13 Langland Gardens,  
NW3 6QD

Basement Impact Assessment  
Audit

London Borough of Camden

Project Number: 12066-94  
Revision: F1

Title  
**Existing and Proposed  
 Basement Plan**

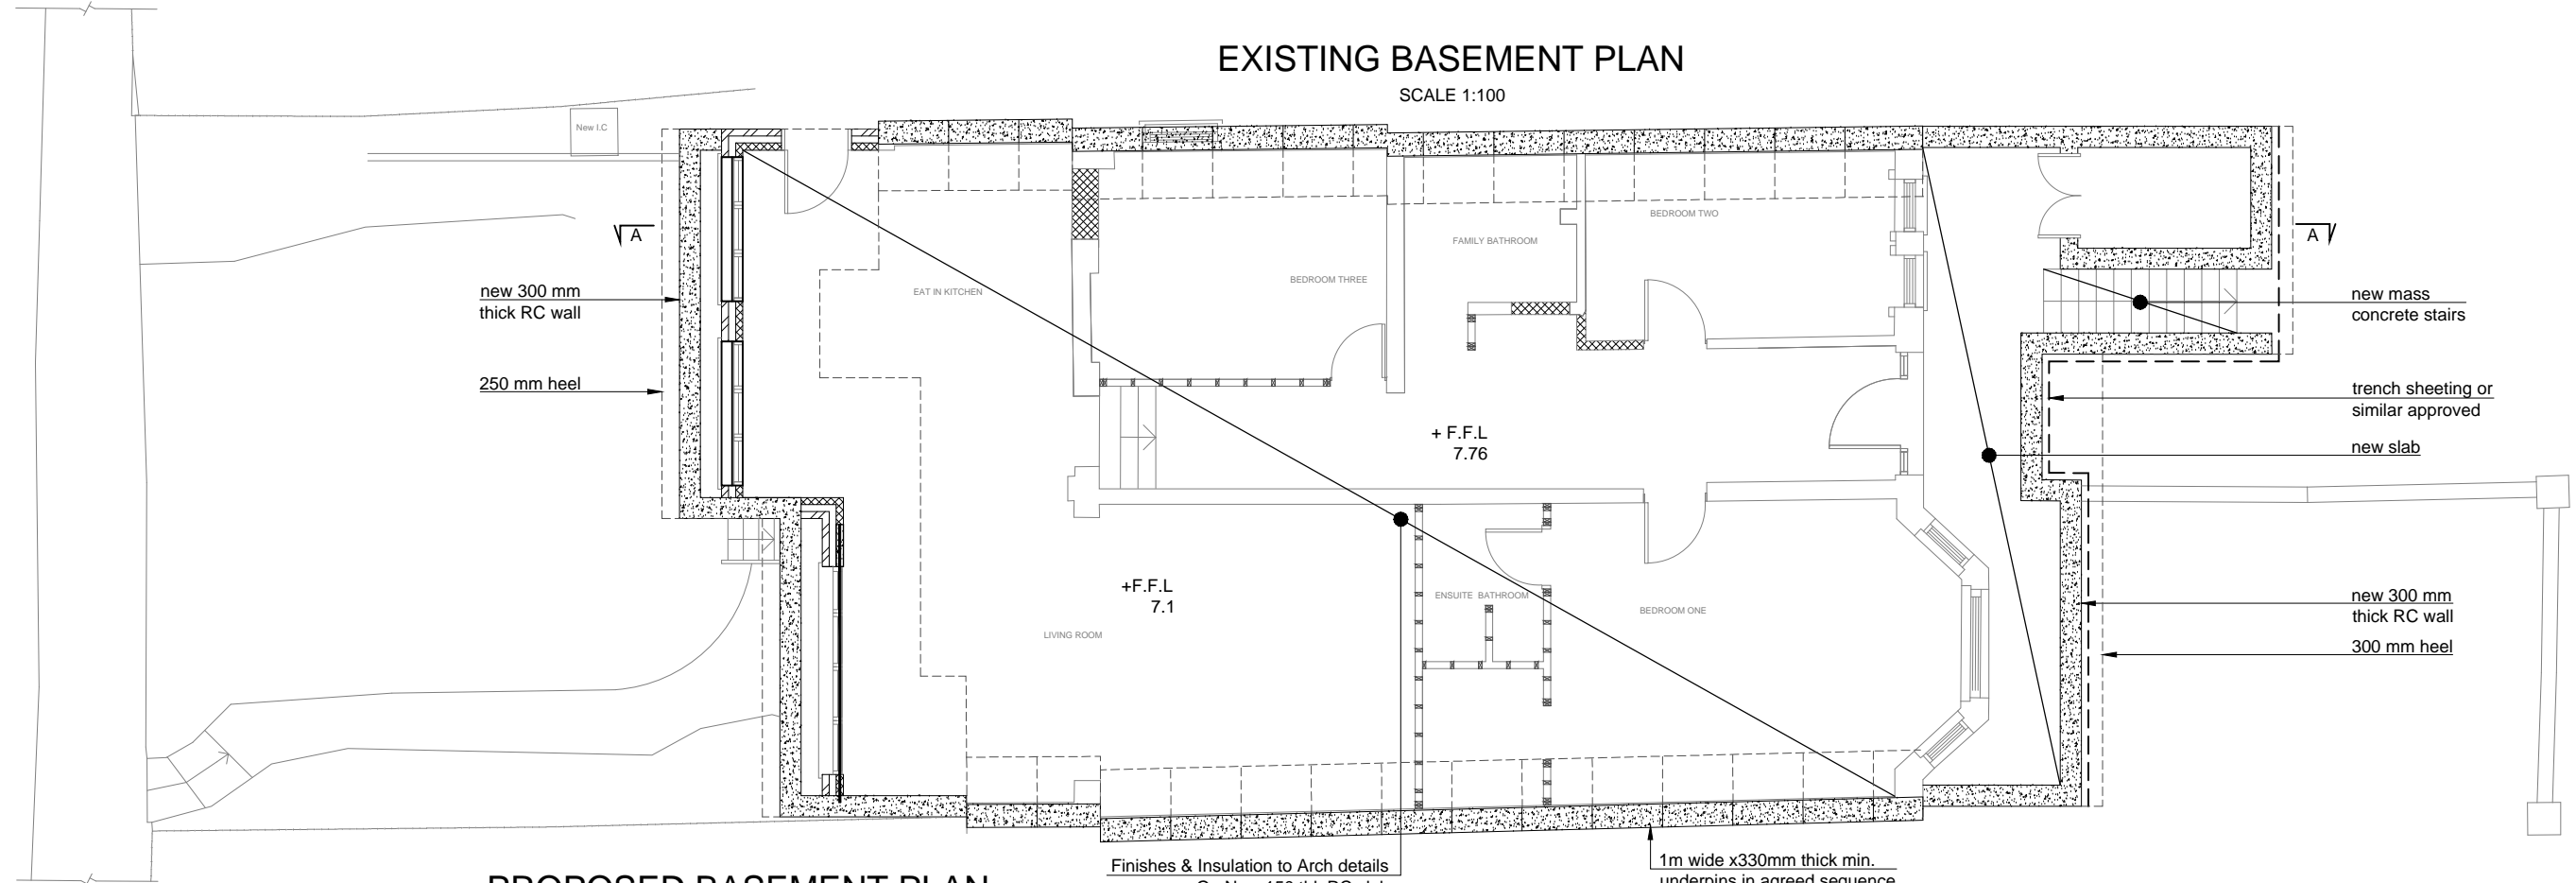
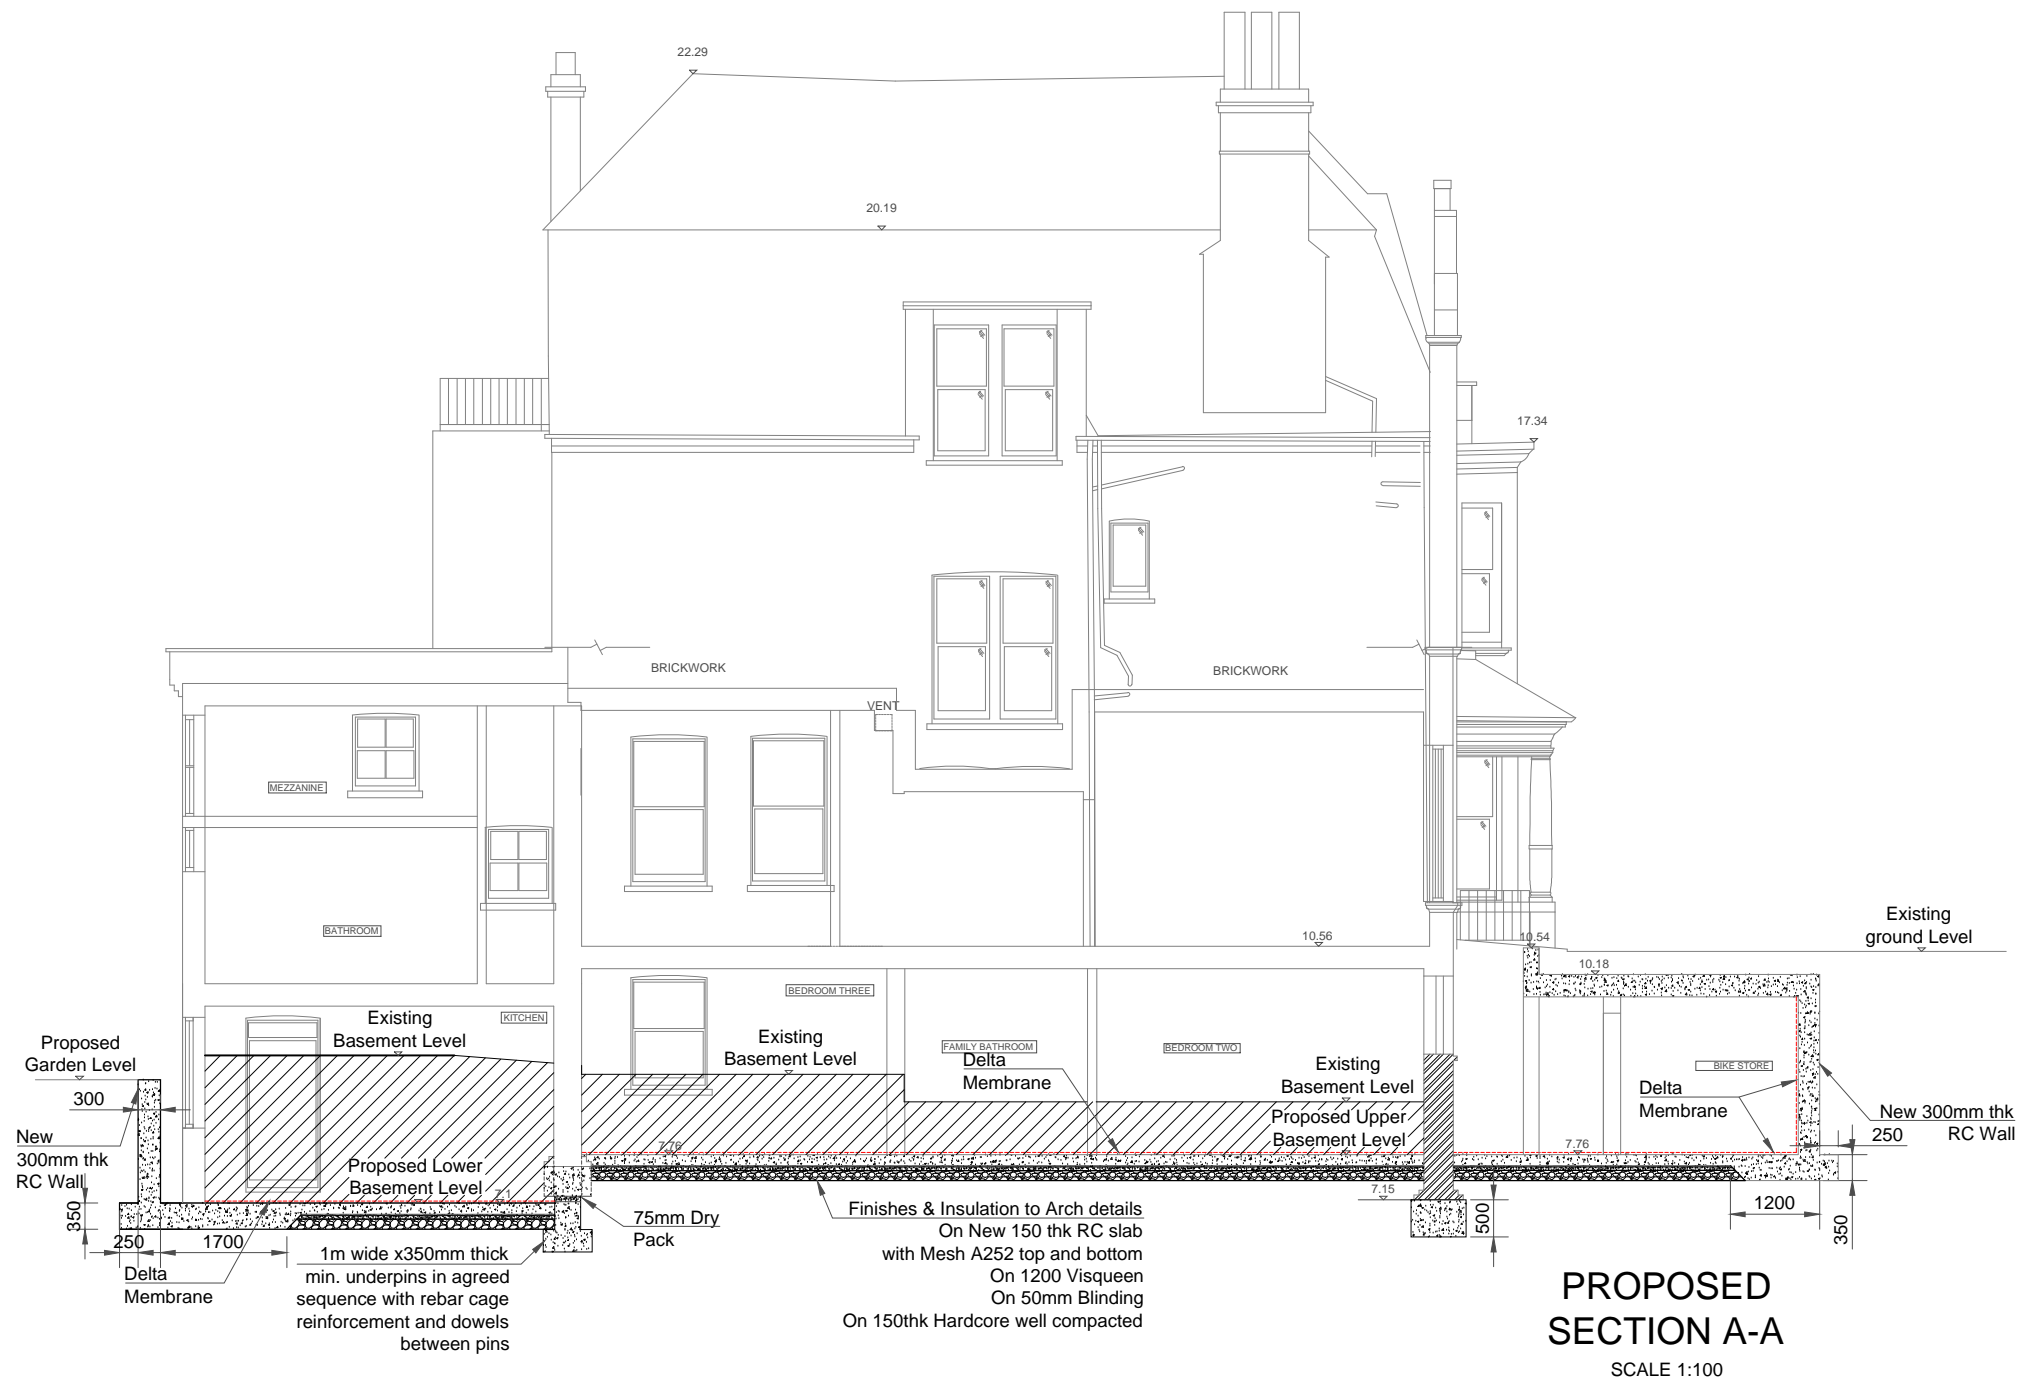
- 4.10. It is noted on the 'Proposed Lower Ground Floor' drawing 13CLANPL100, that a number of columns and walls are to be removed. It is recommended that a review of these superstructure alterations be undertaken, to assess their impact on the existing foundation loadings.

- 4.11. TWS have provided their latest structural layout drawings no. 8803/PA01A, PA03A and PA05 which identify that there appears to be no significant impact on the existing foundations due to changes in superstructure loading.

- 4.8 Please find attached latest structural layout drawings no. 8803/PA01A, 8803/PA03A and 8803/PA05. The change in loading is assessed and we do not see any significant implication or settlement of foundation due to the new construction.
- 4.9 Noted and confirmed.
- 4.10 As the predicted movement is extremely small we do not see any reason to further carry out trial holes at such a distance from the property and works. This request can only be formed once planning is confirmed and party wall agreement is in place.

Project 13c Langland Gardens, London,NW3 6QD		Job no. 8803			
Calcs for Frontbay Lightwell - RC Wall Design		Start page no./Revision 1			
Calcs by NB	Calcs date 04/03/2016	Checked by UM	Checked date 04/03/2016	Approved by	Approved date

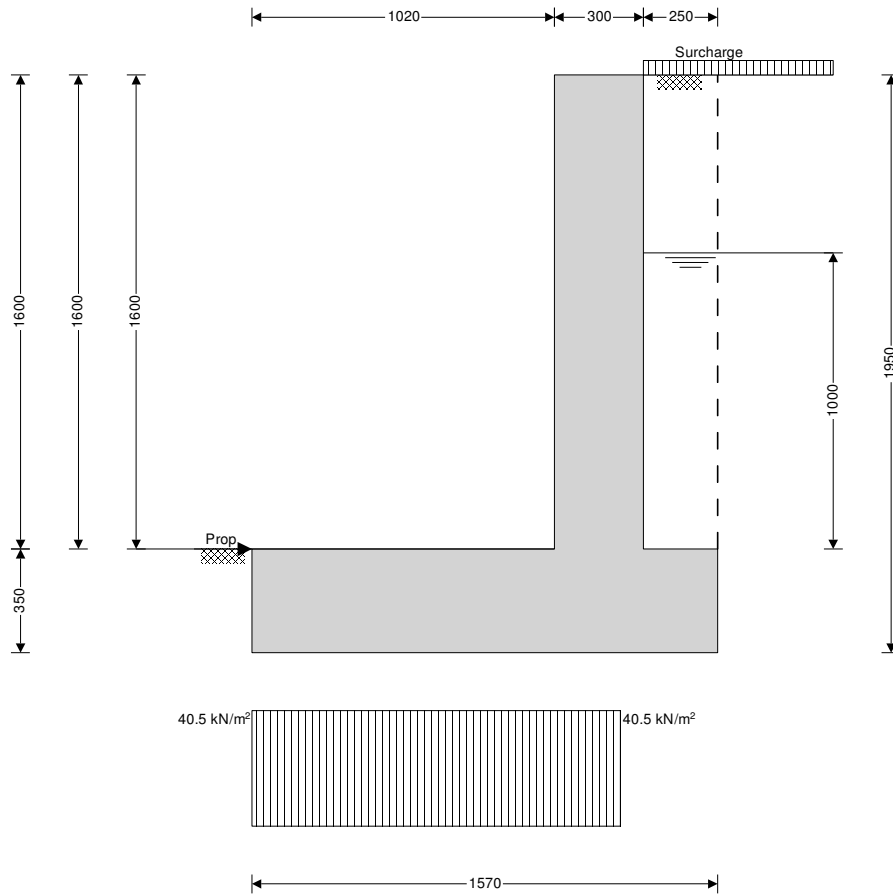
- 4.17. Indicative calculations and associated temporary works for the retaining wall design to the lightwells should be submitted with the BIA.
- 4.18. Additional retaining wall structural calculations provided with TWS's letter dated 7 March 2016 are accepted.

- 4.11 Noted and confirmed.
- 4.12 Noted and confirmed.
- 4.13 Please find attached indicative calculations as requested. This is an initial stage, further calculations and design will be done as part of the building control and party wall agreement.

- 5.6 This is not necessary due to the scale of excavation and depth of underpinning, please refer to my comment under point 4.10.
- 5.7 Please find attached indicative calculations.
